Commissioner of Patents and Trademarks

REMARKS

The amendments made in this preliminary amendment are to correct errors in the drawings and in the specification of this application.

FIG. 2
(PRIOR ART)

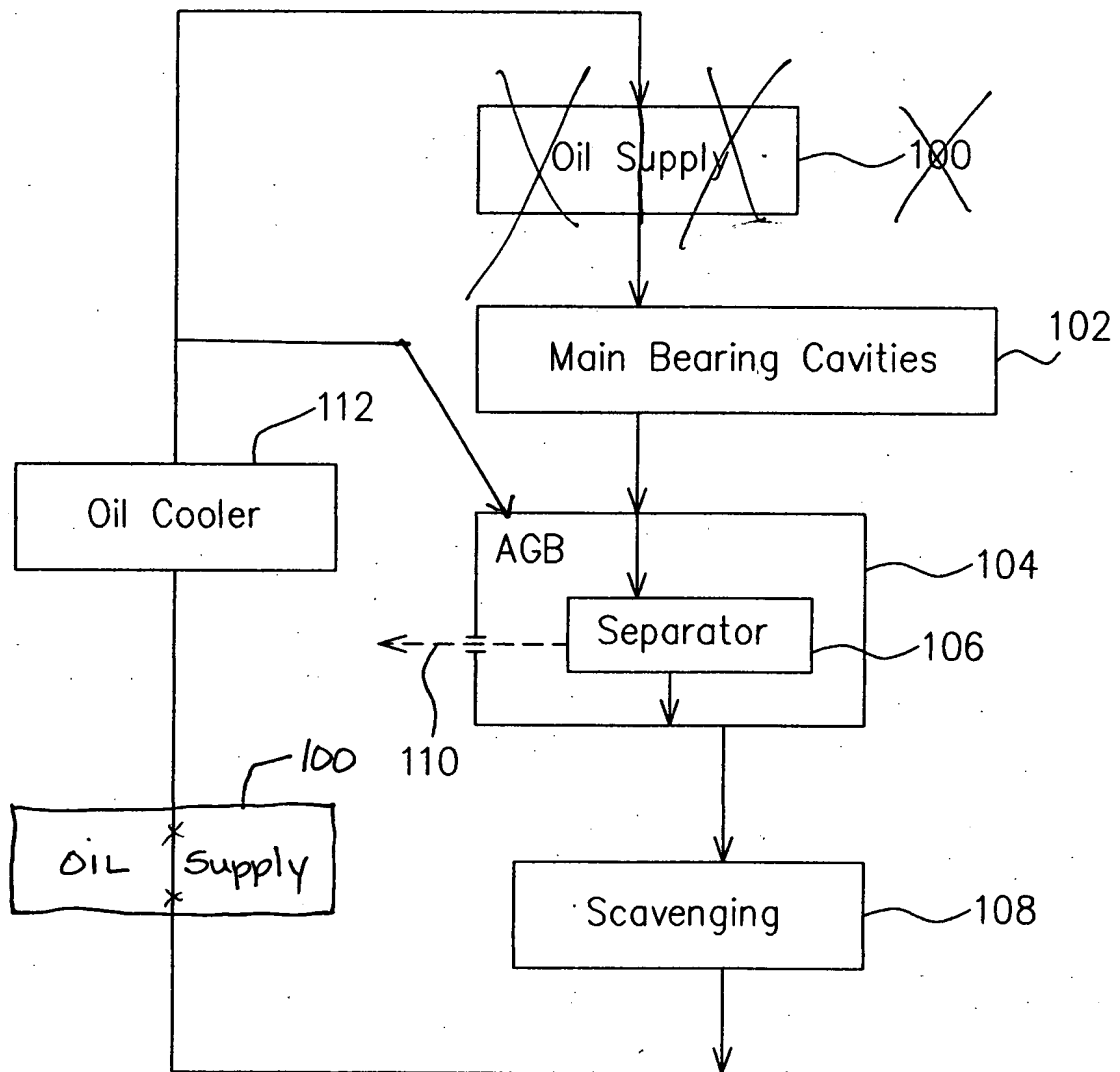
Figure 2 has been amended to more accurately illustrate the prior art which is not part of the invention.

Paragraph [0015] has been amended to reflect the oil directed from the oil supply 100 to AGB 104 as illustrated in the amended Figure 2. This addition is directed to the prior art rather than the present invention.

FIG. 3

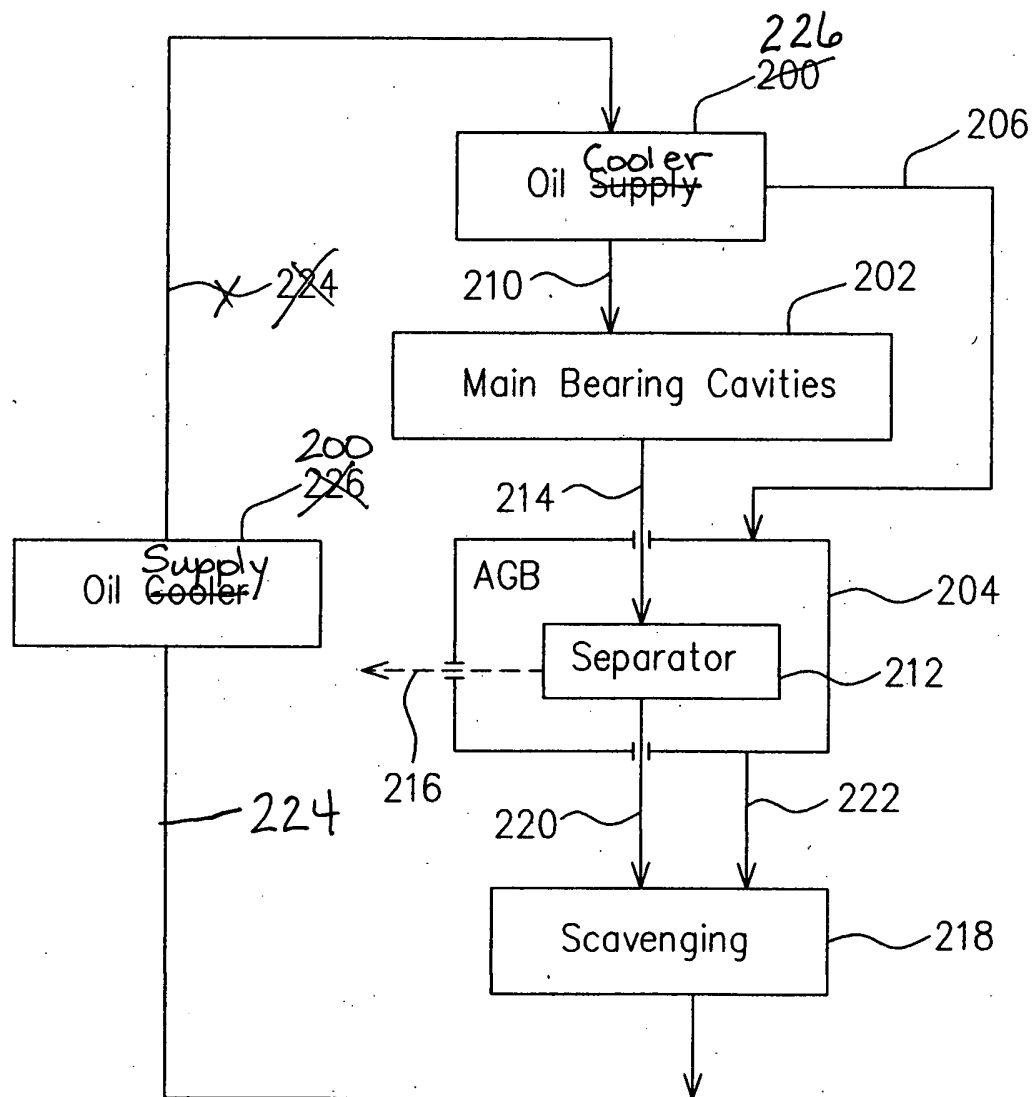
Figure 3 has been amended to accurately illustrate the present invention as described in the disclosure of this application. In paragraph [0018], the method for lubricating an aircraft engine according to the present invention is described as follows:

...the recovered clean liquid oil is then returned from the oil scavenging system 218 to the oil supply source 200 for further use, as indicated by the arrowed line 224. The liquid oil is cooled before re-entering the circuit for lubricating and cooling the one or more main bearing cavities 202 and the AGB 204. The cooling process, as indicated by **the block 226**, may be conducted by any suitable means for cooling which is **connected after the oil supply source 200**,...

It is clear that the originally filed Figure 3 does not accurately illustrate the above description and therefore, should be replaced by the amended Figure 3.

FIG. 4

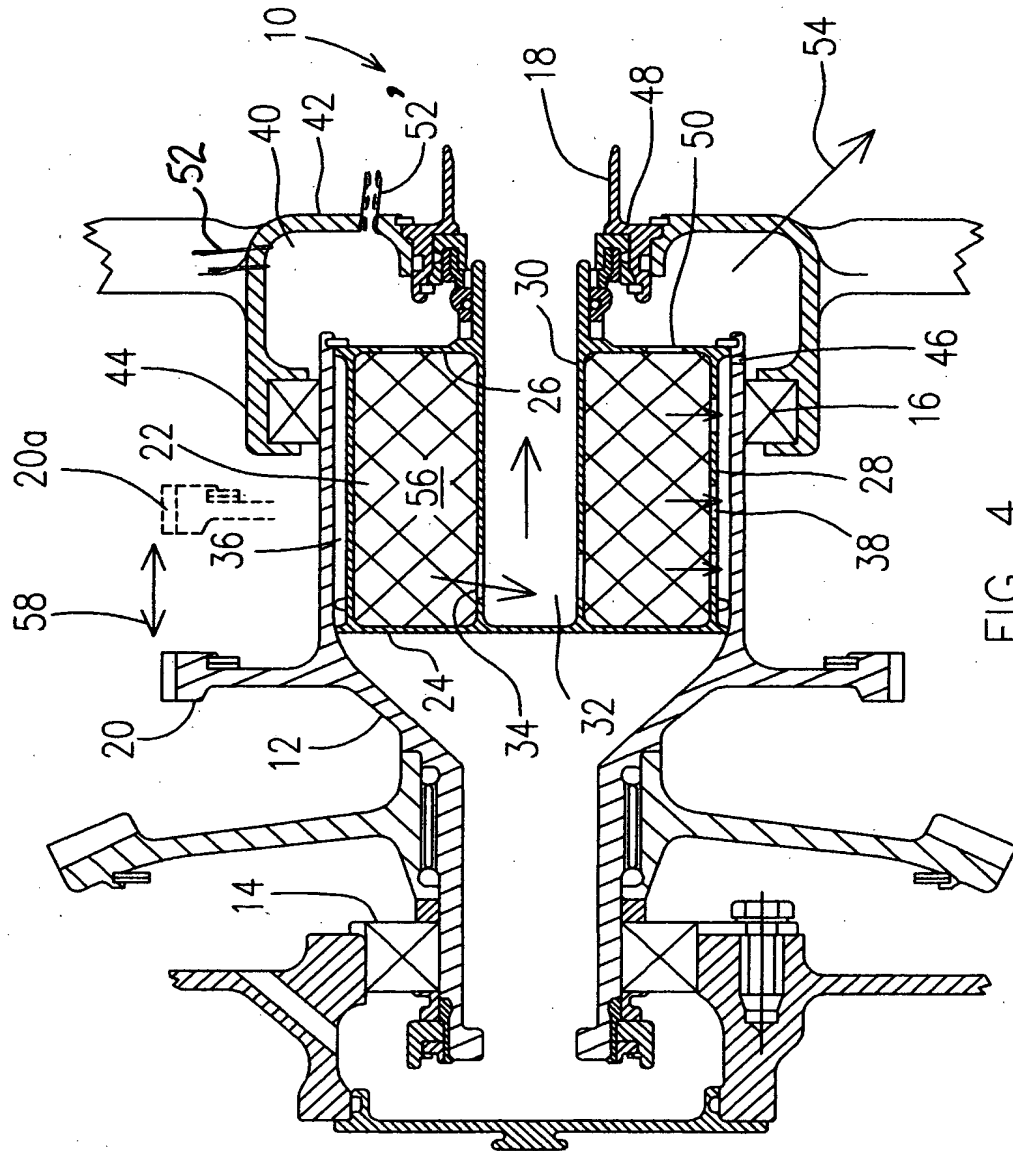
Figure 4 has been amended to agree with the description of both the preferred embodiment and with the alternative arrangement as described in paragraph [0026], as follows:

The tube 52 is connected preferably tangentially with the cylindrical wall 44 of the annular cavity 40 (but could also be in the side radial wall 42)...

However, in order to avoid confusion, the alternative arrangement is illustrated in dotted lines at 52', and a corresponding reference is added to the above description.
